environmental statement

SURRY POWER STATION UNIT 1

DOCKET NO. 50-280

May 1972

Fig. 3.14. Predicted thermal plumes for Surry Power Station during ebb tide periods for (a) summer operation, and (b) winter operation.

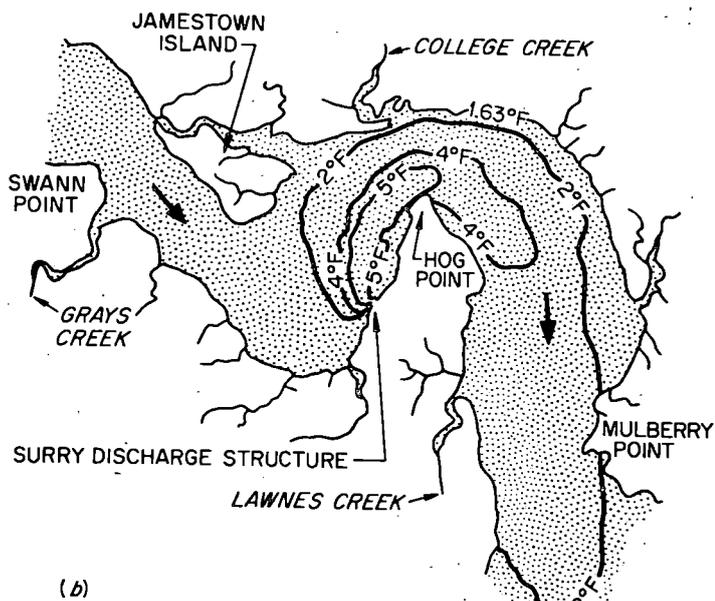
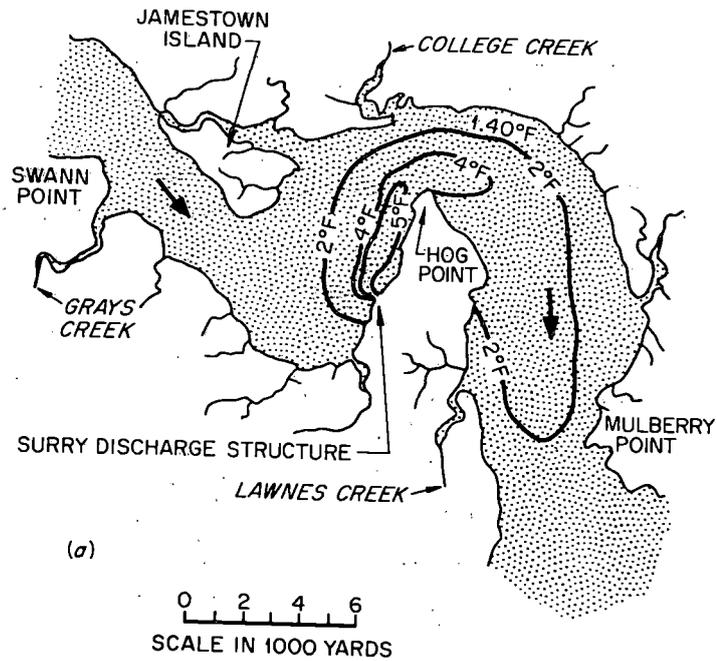
A quantitative discussion of thermal plume behavior appears on pages 54-59. Based on figures 2.10, 3.13, and 3.14 (pp. 35, 56 and 59), it appears that heated water will be recycled through the plant during ebb and slack tide. Although we realize that

Our evaluation of plume behavior and effects is also hampered by the lack of certain needed information which makes it difficult to verify the accuracy of the predicted thermal plumes. This information, describing the characteristics of the thermal plume, should be presented in support of Figure 3.13 and should include a description of the depth of the heated zone, indicate the minimum temperature isotherm with which the plume is being defined, and show the 1.5°F isotherm for summer conditions.

It is evident from Figure 3.14 that a portion of the plant effluent will be recirculated during the late ebb and slack before flood periods of the tidal cycle. Approximately 14% recirculation will occur during this 1.5 hour time interval - this is equivalent to 2% recirculation averaged over a complete tidal cycle. The effect of this recirculation should be virtually nil for reasons that become evident by following the course of events of one tidal cycle, as described in Section III.D.1.c of this Statement.
